**NOTICE OF PUBLIC HEARING**  
**Minor Variance**

<b>APPLICATION NO.:</b>	<b>FL/A-22:380</b>	<b>SUBJECT PROPERTY:</b>	40 MacBean Cres, Flamborough
<b>ZONE:</b>	“R1-31” (Urban Residential (Single Detached) Zone)	<b>ZONING BY-LAW:</b>	Zoning By-law former Town of Flamborough 90-145-Z, as Amended

**RE: APPLICABLE LAW REVIEW – ZONING BYLAW COMPLIANCE REVIEW**  
**PRESENT ZONING: R1-31**  
**ADDRESS: 40 MACBEAN CRES. FLAMBOROUGH**

**1 SITE PLAN**  
 SCALE= 1:100

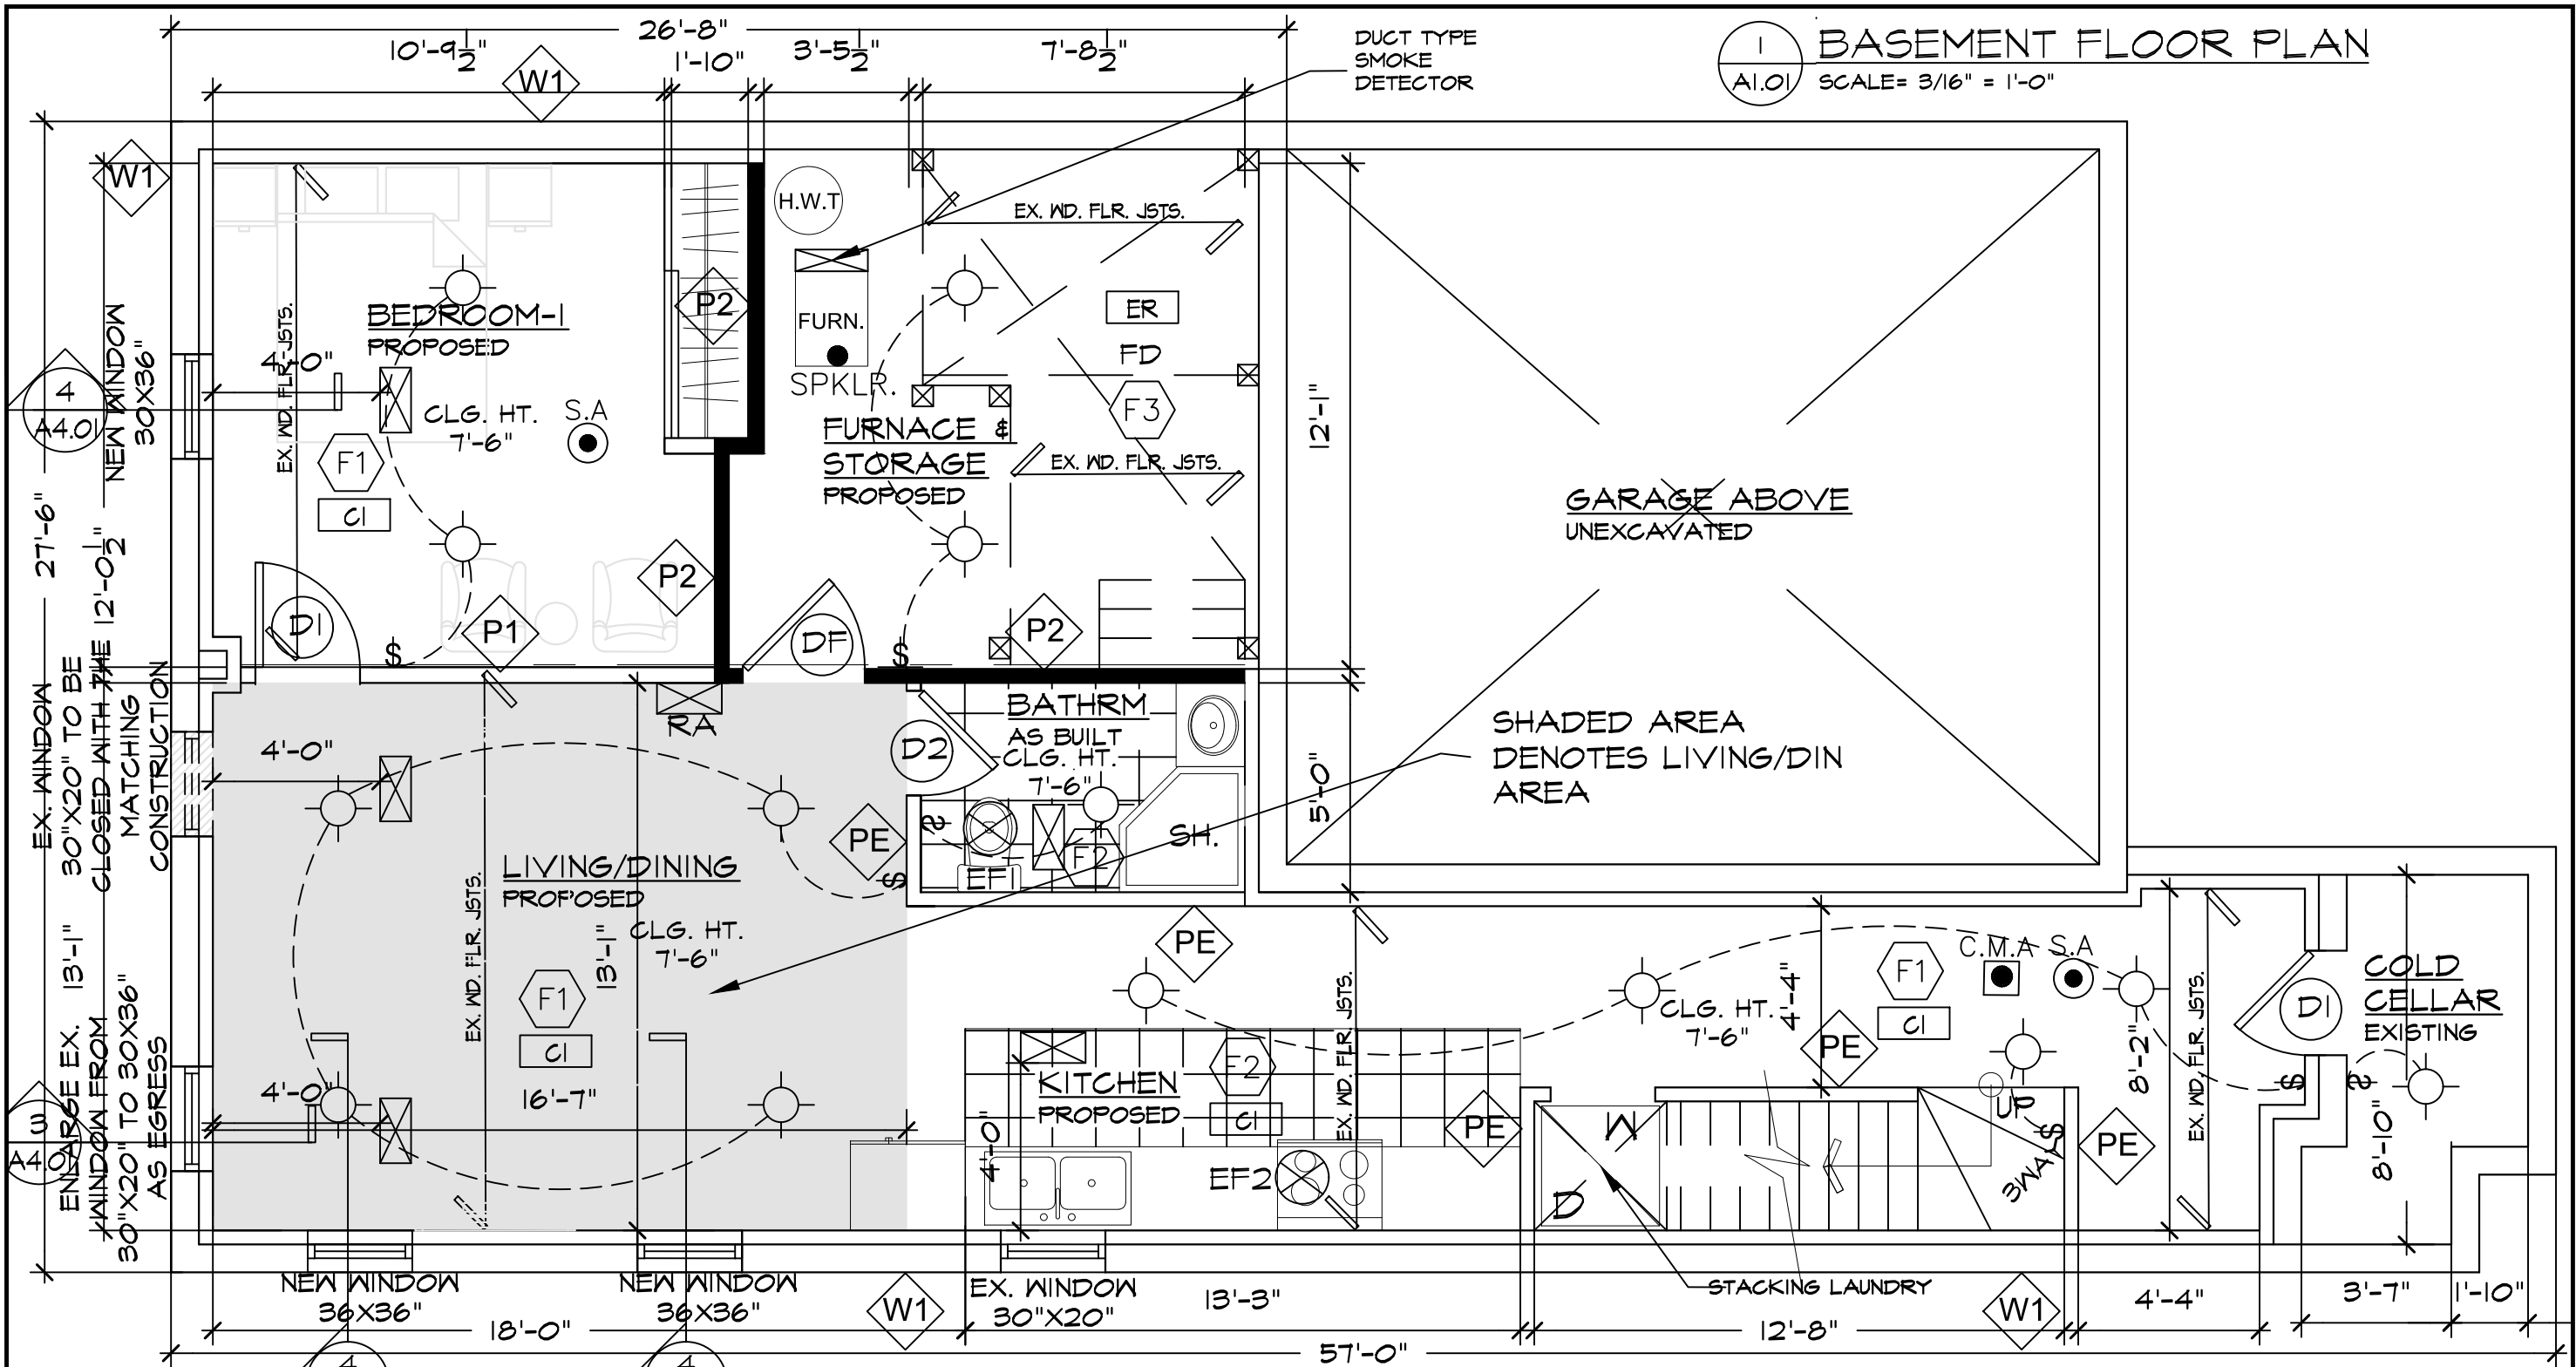
<b>Section 5.12 - Minimum Landscape Requirements</b>			
<p><b>Landscaped Open Spaces</b> [Section 5.12.1 of Flamborough Zoning By-law 90-145-Z]</p>	Within any Residential R1, R2, R3, R4, R5 and R6 zone, a minimum of 50% of the front yard shall be landscaped.	Insufficient information has been provided in order to determine zoning compliance.	<b>Unable to Determine Compliance</b>
<b>Yard Encroachments – Steps</b>			
<p><b>Yard Encroachments</b> [Section 5.30 of Flamborough Zoning By-law 90-145-Z]</p>	Steps may only encroach into a required front, required rear or required exterior side yard to a maximum of 1.5m	<p>The proposed steps (associated with the new access door to the Secondary dwelling unit are intended within an Interior Side yard.</p> <p>As Section 5.30 does not specifically permit steps to be provided into an interior side yard, these steps are required to meet the minimum required side yard setback for the principal building.</p> <p>As such, the steps are required to be at least 1.2m from the side lot line.</p> <p>The proposed steps appear to be +/-1ft from the side lot line.</p>	<b>Non-Conforming</b>

2 ENLARGED PROPOSED GR. FL. PLAN  
 A1.04 SCALE= 3/8" = 1'-0"

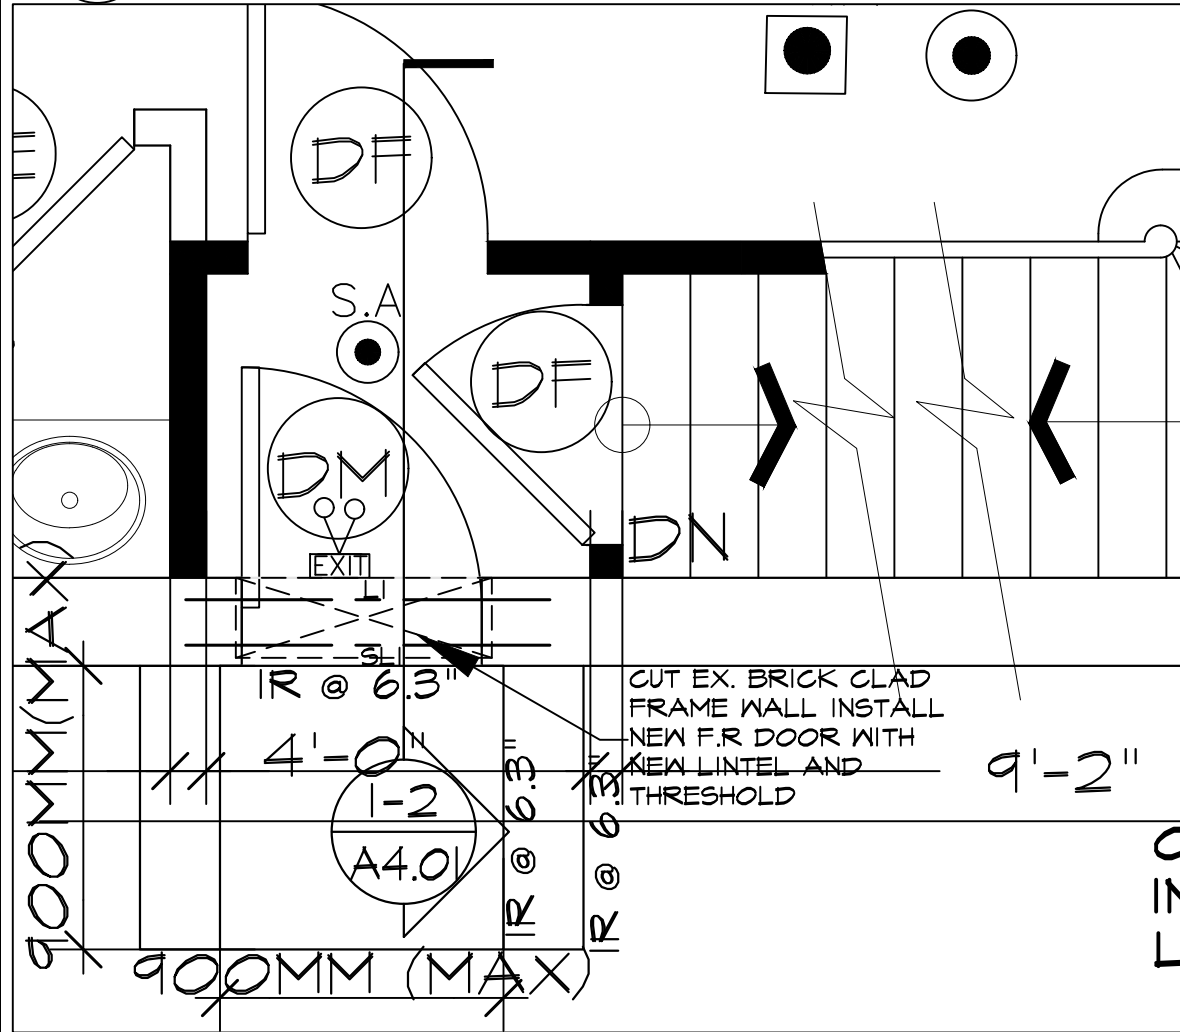
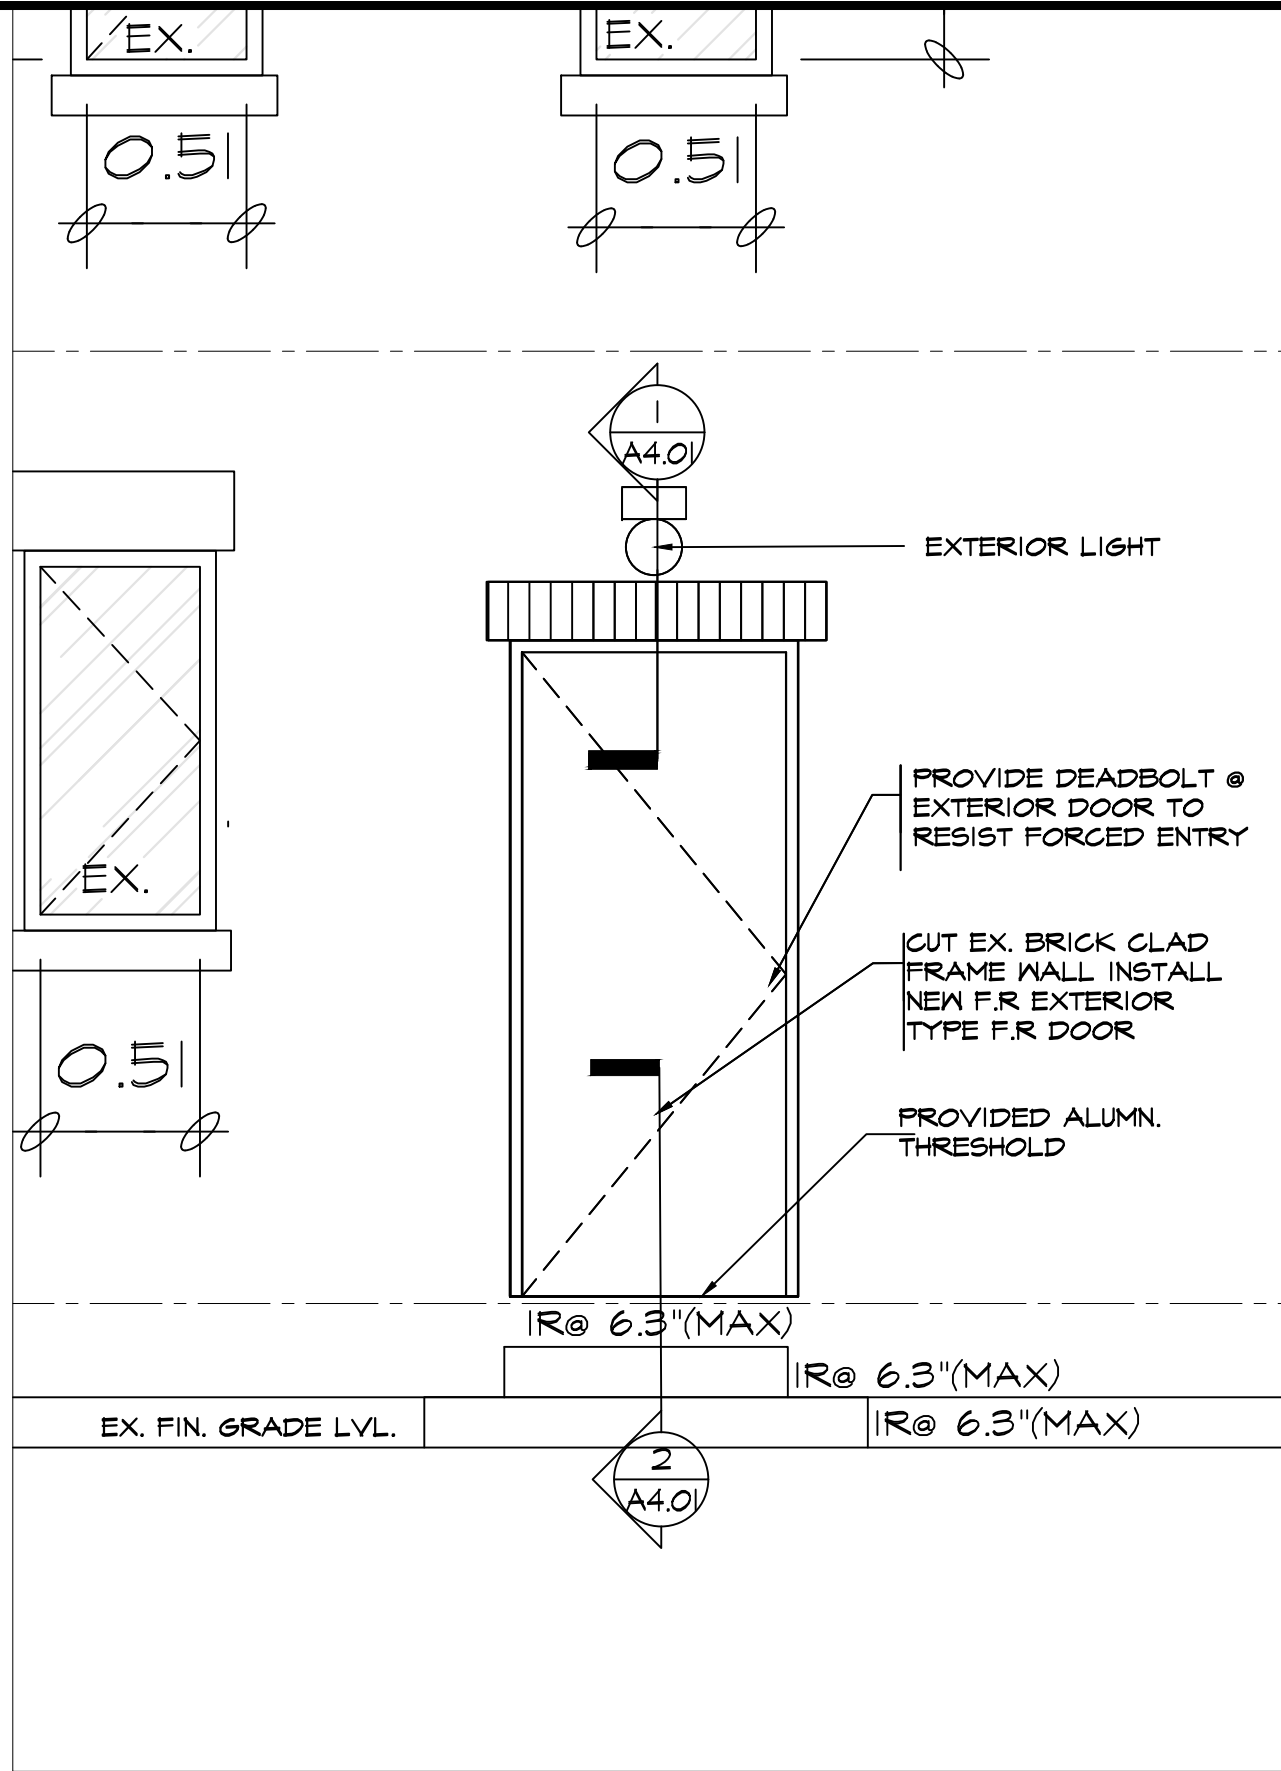
1. Steps shall be permitted to project 0.9m into a required side yard (therefore being 0.3m from the side lot line), whereas the by-law prohibits steps to project into a required side yard.
